SUBJECT: Massachusetts Department of Transportation (MassDOT)
Allston Multimodal Project
Multimodal Connections Working Group
Meeting Summary as of August 13, 2024

On August 9, 2024, the MassDOT team for the Allston Multimodal Project virtually held the first meeting with the Multimodal Connections Working Group. The Working Group (WG) discussed the concept designs for four configurations of the Franklin Street Pedestrian Bridge.

Figure 1: Design Option 1

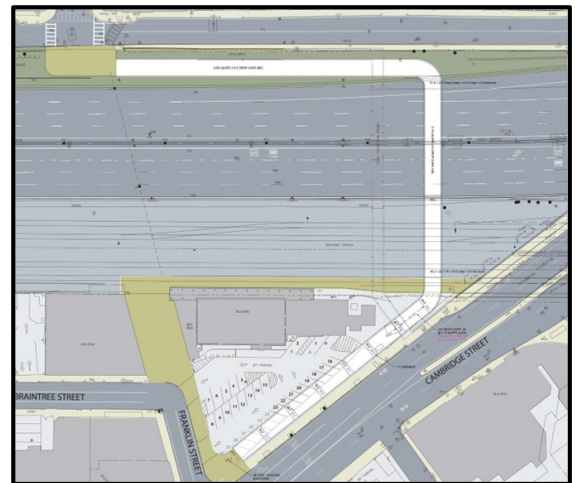
The access ramp option provides a crossing at a similar location to the existing bridge. The ramp provides access for cyclists and pedestrians. The majority of the Working Group members are familiar with this option as it has been presented in the 2017 Draft Environmental Impact Report and at various Task Force and Public Meetings over the past several years. This design is attractive due to its more simplified alignment; however, it has been determined to be less than optimal due to an acquisition taking from a historic property, and the fact that it reduces parking spaces immediately adjacent to the restaurant. The access ramp

option is prohibitive as it interferes with the historically protected Allston Depot parcel and has been dismissed from further study.

Figure 2: Design Option 2

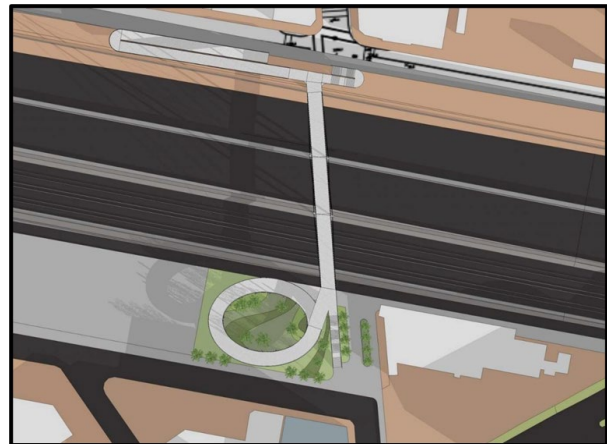
The spiral ramp option provides pedestrians with stair and ramp options with a direct connection to Franklin Street and the proposed Southside Buffer Path. The majority of the Working Group members are also familiar with this option as it is a variation of the preferred Location 3 bridge option presented in the 2017 Draft Environmental Impact Report with the switchback ramps being replaced with the spiral ramps. Option 2 has also been presented at various Task Force and Public Meetings over the past several years. The bridge would be constructed using cable stays, allowing for a more impactful and iconic design. This option would require a taking of the former Ace Ticket building and a portion of the adjacent parking lot parcel. The existing billboard on the former Ace Ticket building property would also require relocation. There would also be potential utility line and/or utility vault

impacts at the stair and support column foundation locations.

Figure 3: Design Option 3

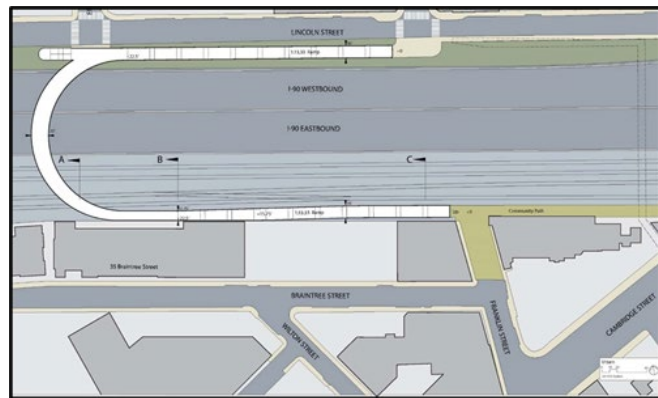
The project team also explored a two-bridge option providing ADA accessible crossing via U-shaped bridge alongside a direct staircase bridge north/south crossing from ramp entry/exits. Impacts associated with this option are listed below.

- Comments:
 - Additional property impacts within private portion of Franklin Street Extension adjacent to former Ace Ticket building.
 - Feasibility challenges due to major utility line and/or vault impacts at stairs and support column foundation locations

- The Indie apartments (35-43 Braintree Street) property adjacent to the railroad tracks and potential U-turn alternative is configured with only parking and resident amenities on the lowest floors, making the U-turn alternative a possibility that would not encroach on the privacy of residents.

Figure 4: Design Option 4

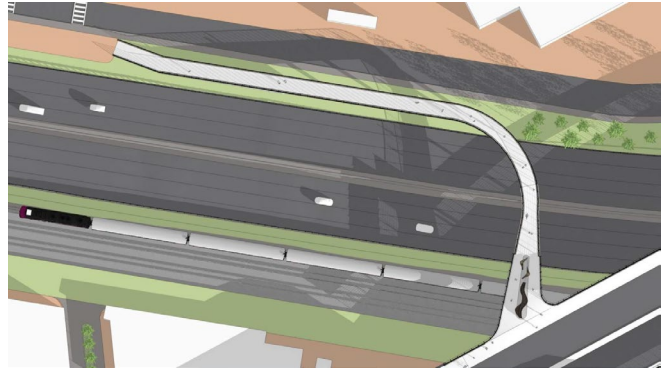
- Design provides an ADA-compliant solution.
- Minimized impact to surrounding properties. No impact to Historic property, parking spaces or existing billboard.

- Creative solution to provide a more manageable travel distance for pedestrians.
- Similar length and placement to the existing bridge.
- Provides a more direct walking and cycling connection to Linden Street.

- Allows wide paths for both cyclists and pedestrians.
- Linden Street is a local street under City of Boston ownership. It runs adjacent to Cambridge Street and is commonly used as a pedestrian alternative for those traveling toward Brighton Avenue and Commonwealth Avenue. It allows travelers to circumvent the intersection of Cambridge Street and Harvard Avenue and is perceived as a safer option for pedestrians. The Harvard Avenue and Cambridge Street intersection is very dangerous for pedestrians. A Linden Street connection is necessary to allow pedestrians to avoid the intersection.

- A mid-block crossing is desirable as pedestrians currently cross without priority, Question if this option could be connected directly to the SSBP
- Arcand expressed general support of the fourth alternative, pointing out that it addressed many concerns the group had previously mentioned.

- Moving the pedestrian bridge connection to the east will make the distance greater for Franklin Street residents.
- Concern was expressed for the safety of cyclists and pedestrians looking to connect with the street network from the pedestrian bridge.
- Intersection with Cambridge Street opposite Linden Street would need to be evaluated for safety and stop controlled
- Will this alternative be possible without disrupting the existing pedestrian bridge? Minimal impact with bridge closures will be important.
- Visual representations need to be easier to decipher for group members.

- Based on feedback from this meeting, the project team will:
 - Explore refinements to concept designs.
 - Create visual representations showing regional context.
 - Continue discussion with MBTA, Amtrak, and CSX regarding the future of existing rail yard.
- Next WG meeting to be held on **August 23, 2024**.
- The WG will not meet on August 16.

Appendix A: Rita Arcand Revised Design

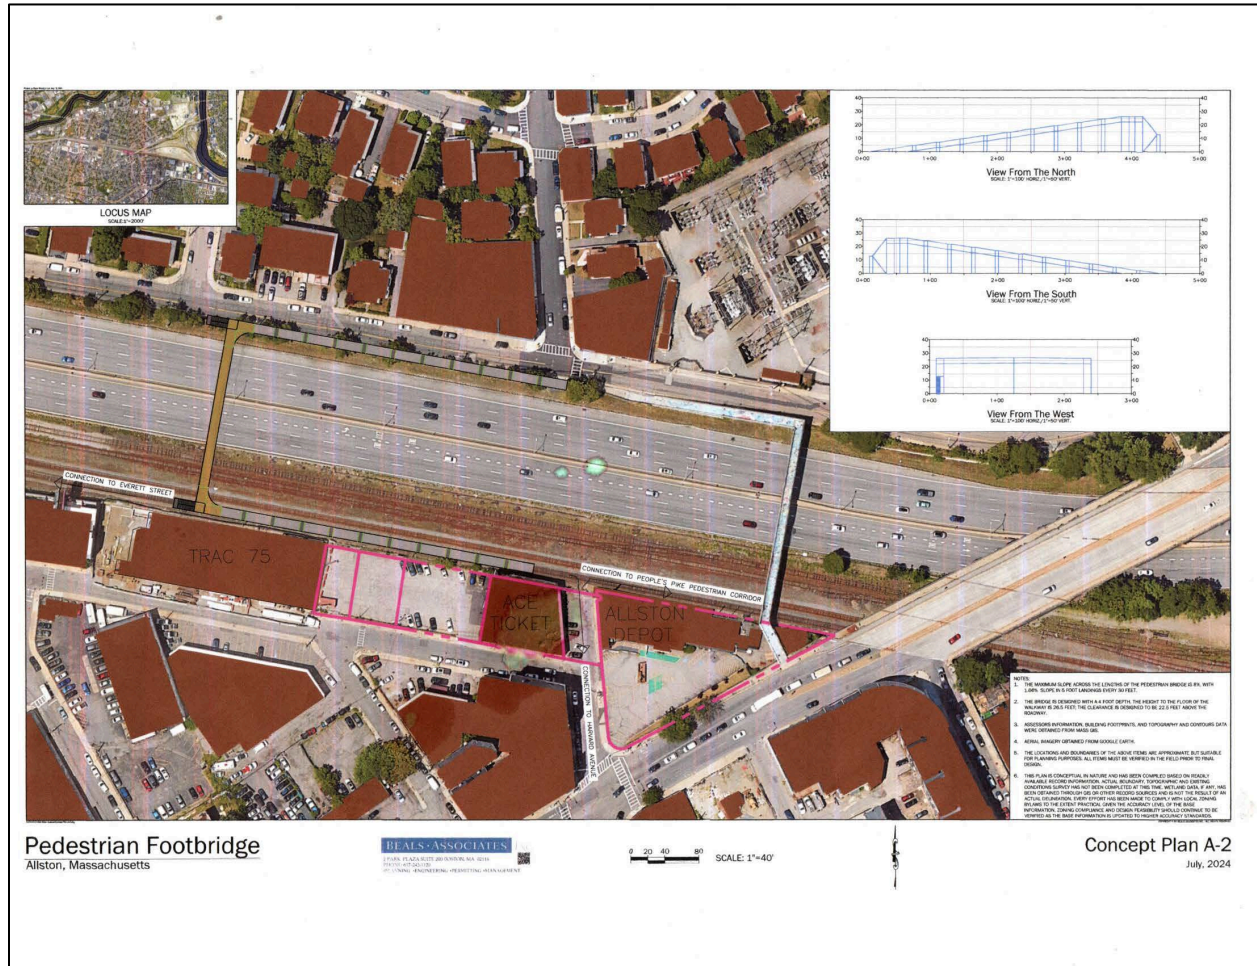
- Rita Arcand separately submitted a revised design for the Franklin Street Pedestrian Footbridge. The aim was to shorten the loop by trying to reconfigure the crossing and soften the corners to avoid right angles. The revised design can be found in Appendix A.
